ADDENDUM NO. 1

**TRI-COUNTY SCHOOL JR-SR HIGH SCHOOL BACKPACK ADDITION &
NEW MAINTENANCE FACILITY
Wolcott, IN 47995**

ADDENDUM ONE

Addendum One (AD.01) to the drawings and specifications prepared by Gibraltar Design for **Tri-County Jr/Sr High School Backpack Addition & New Maintenance Facility** for Tri-County School Corporation, Wolcott, Indiana.

4. Sheet A-101

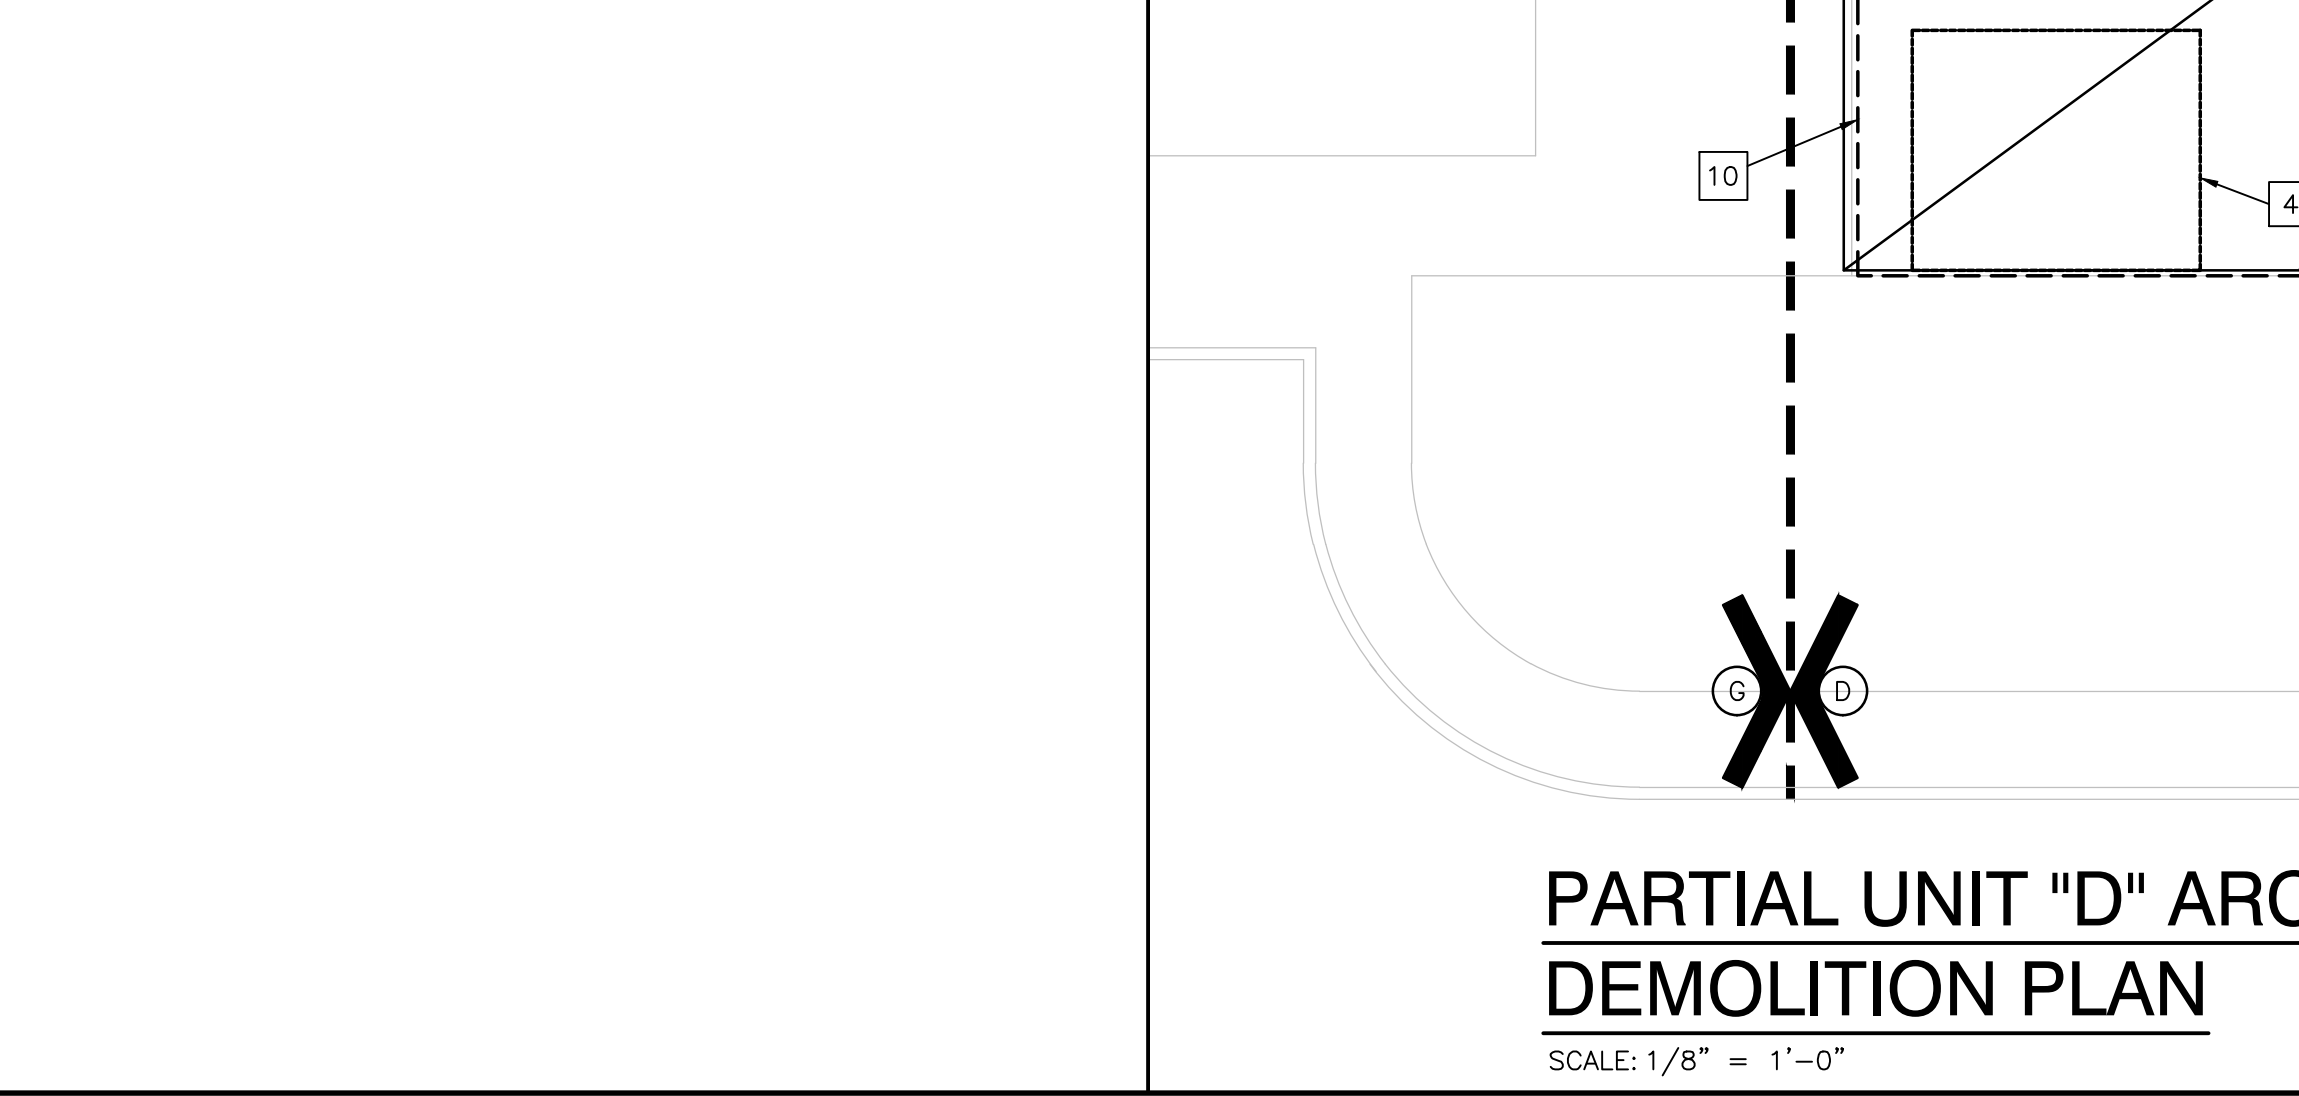
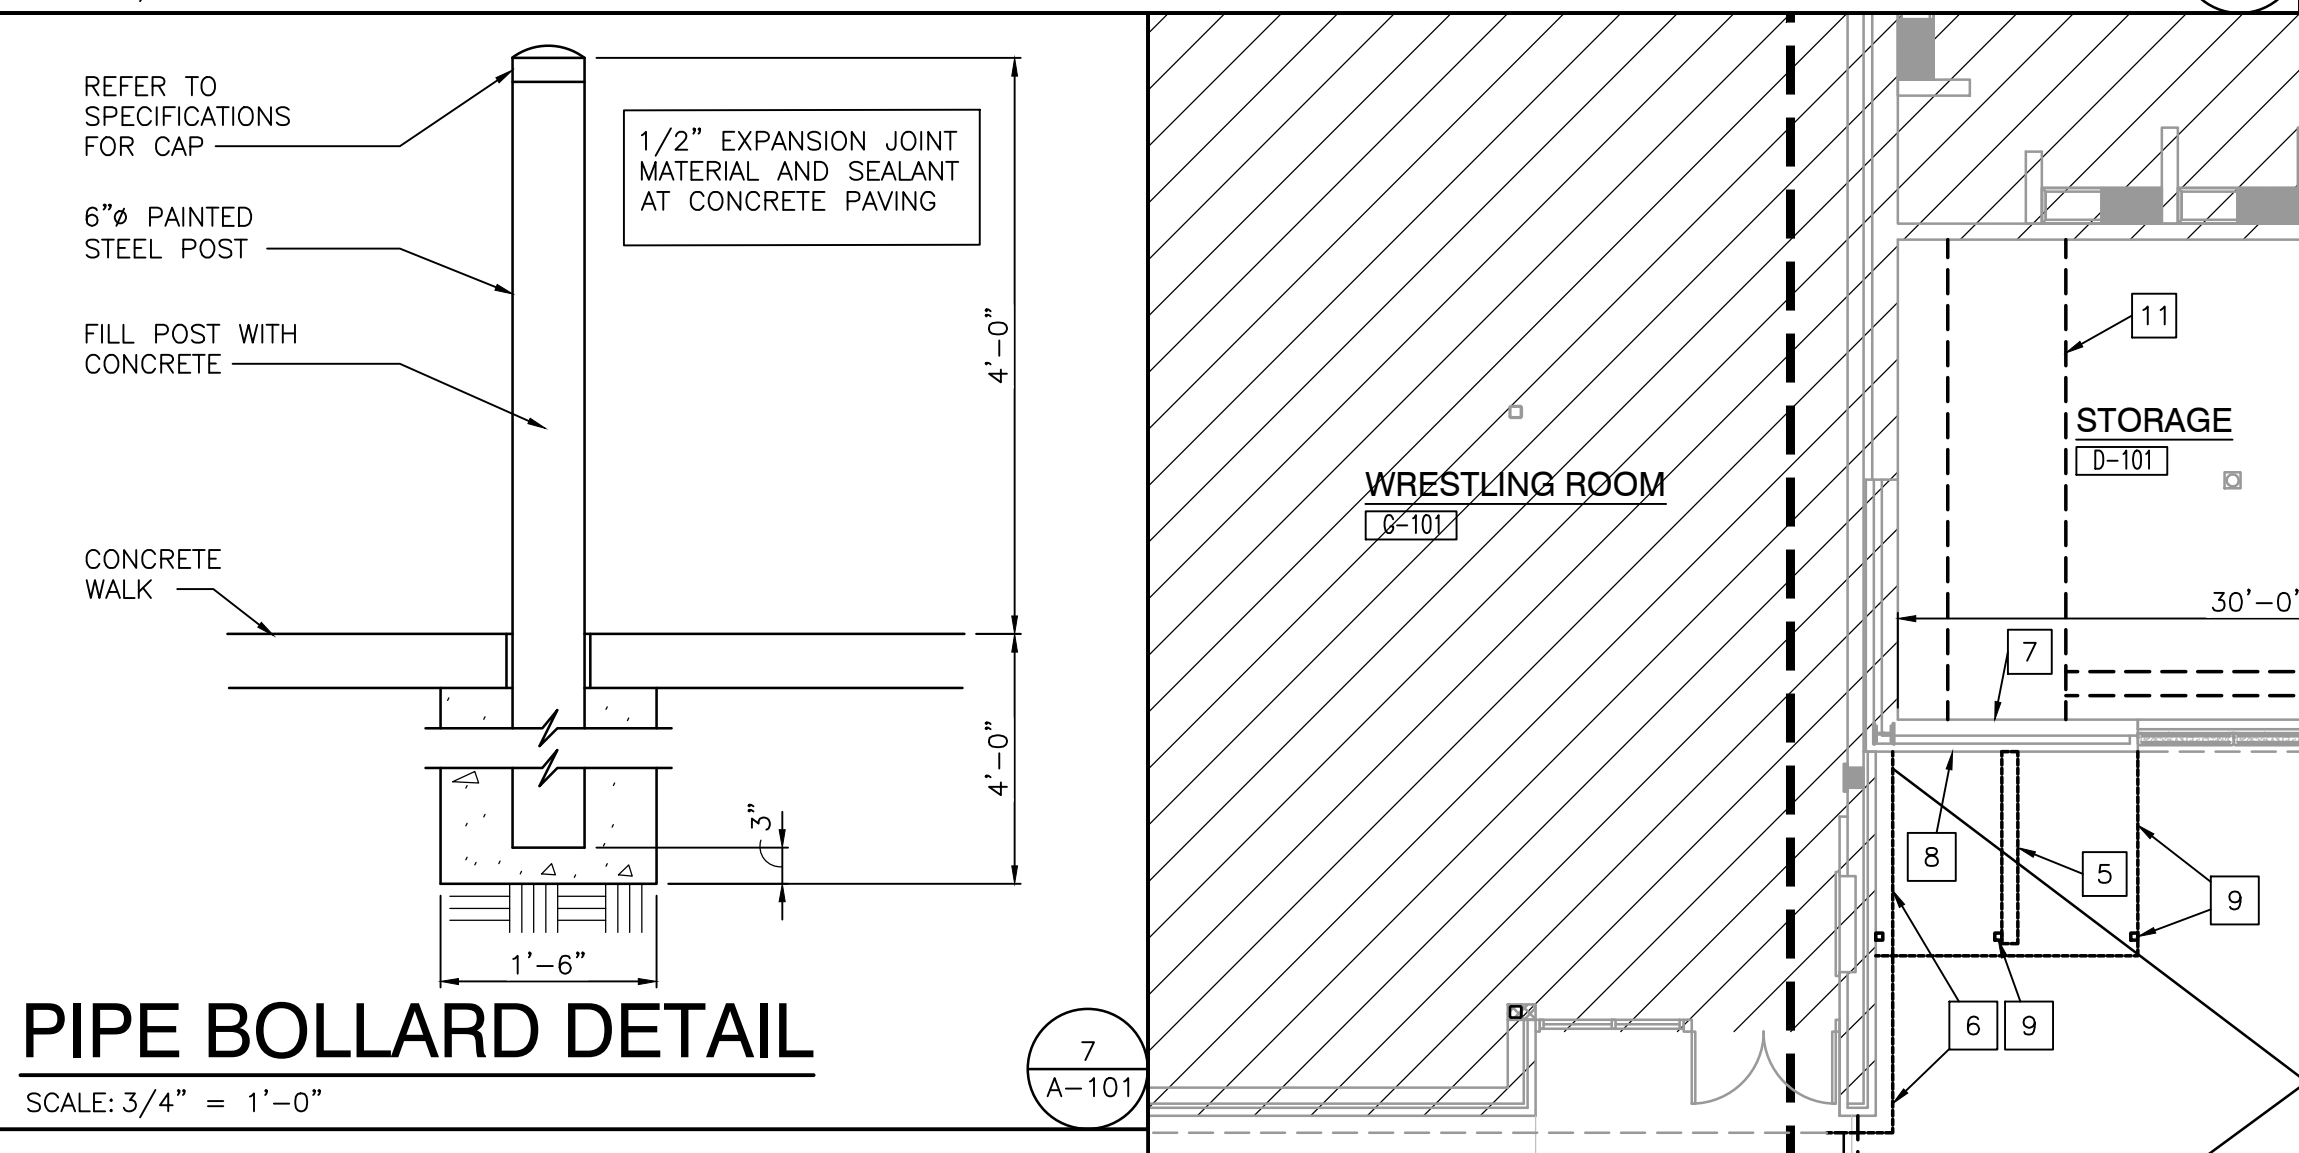
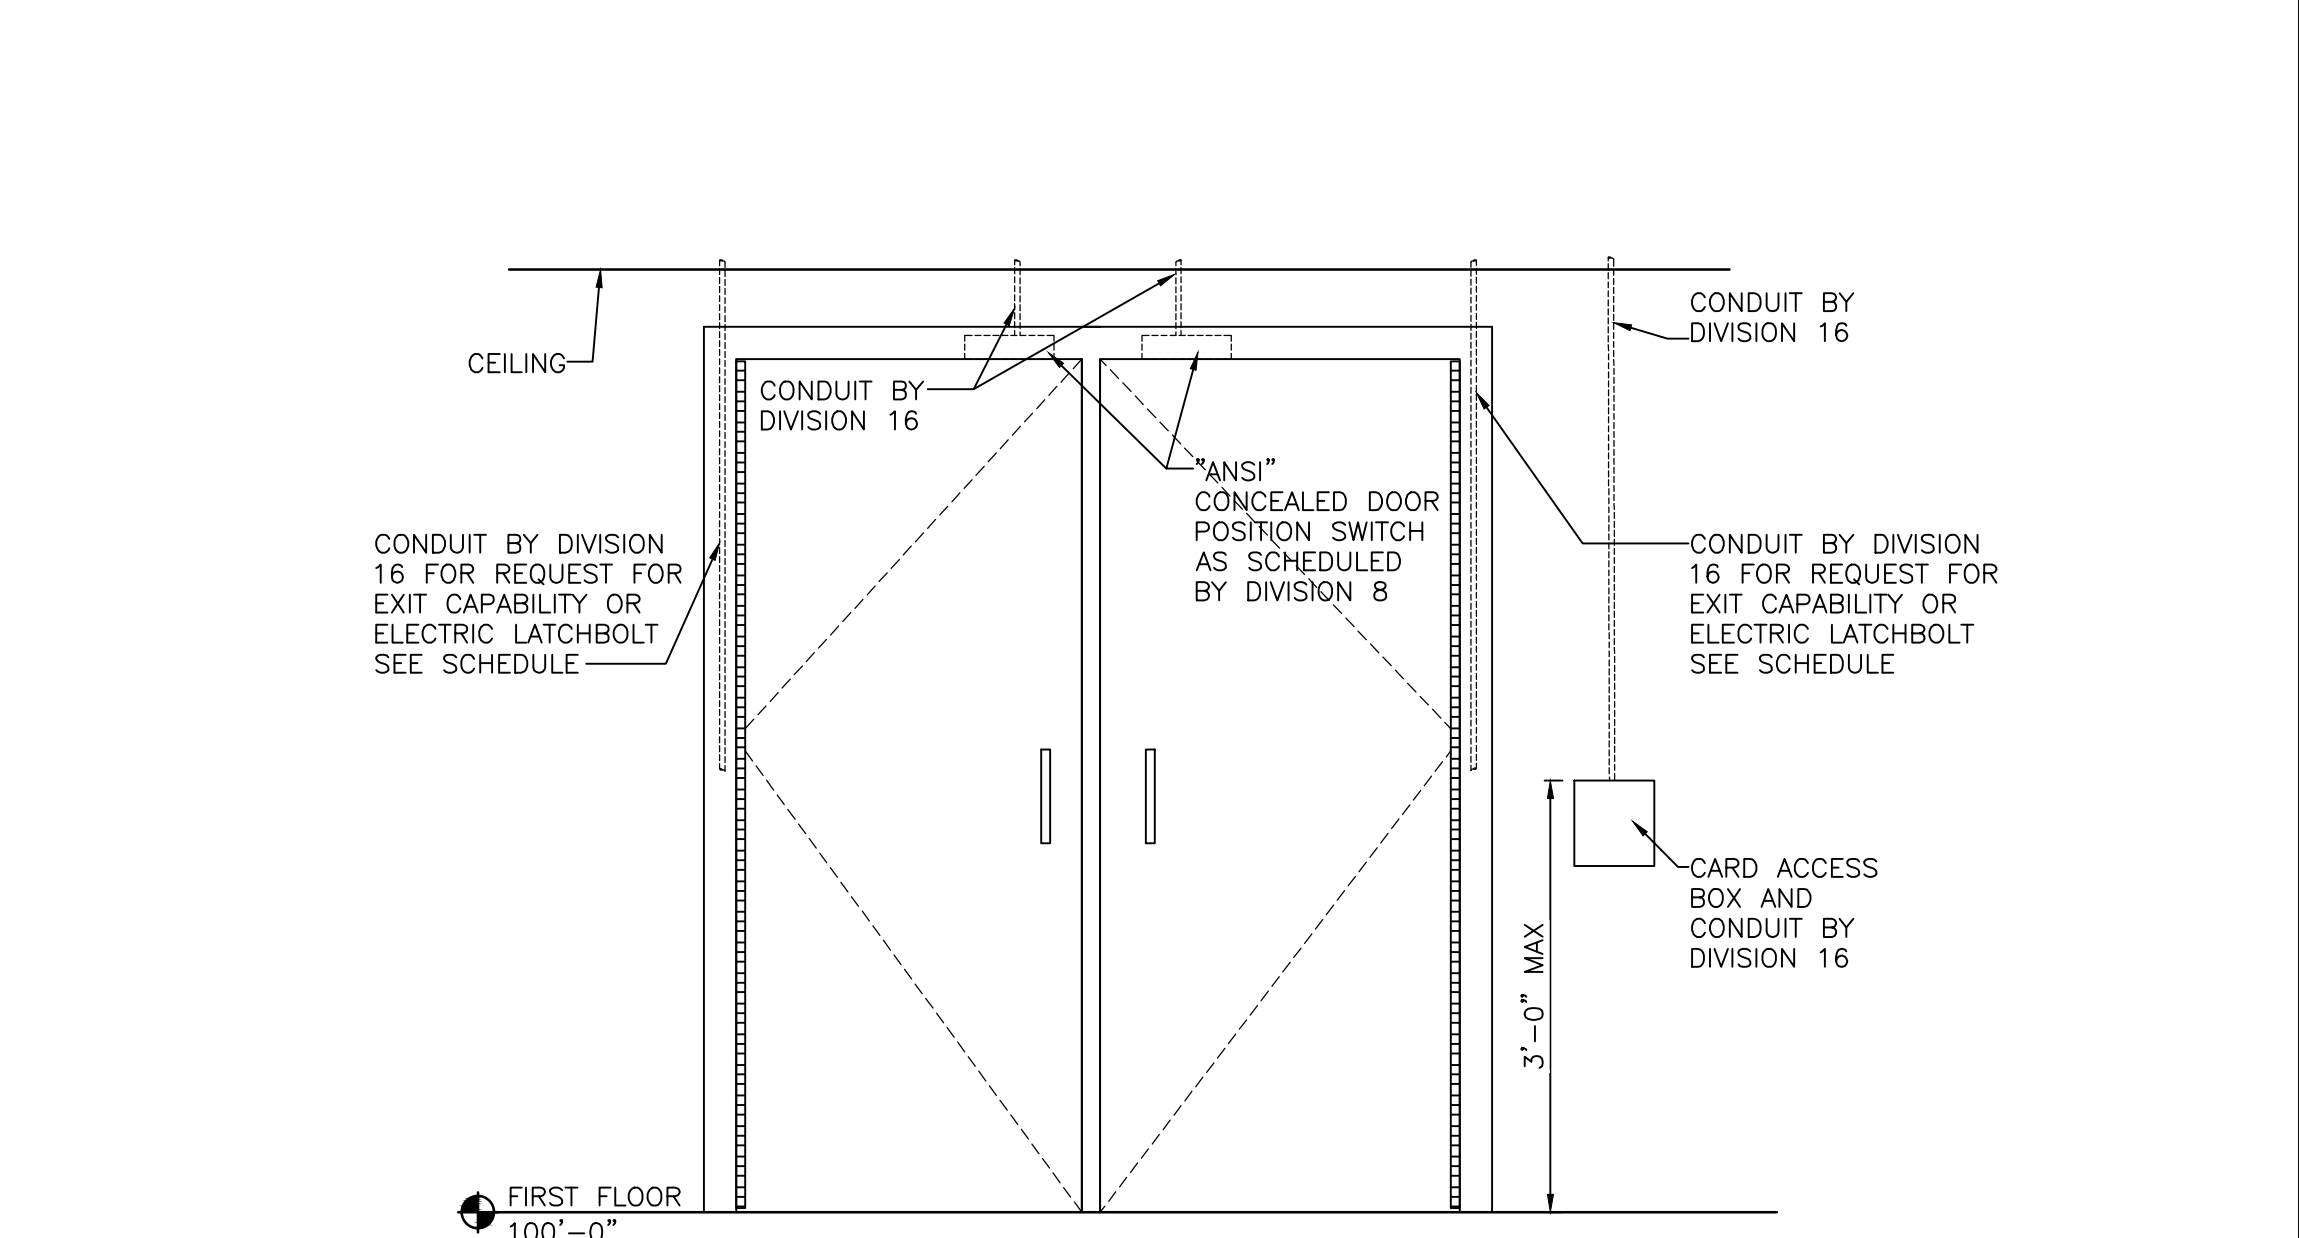
- A. Revised plan notes.

5. Sheet A-103

- A. Revised Wall section 2
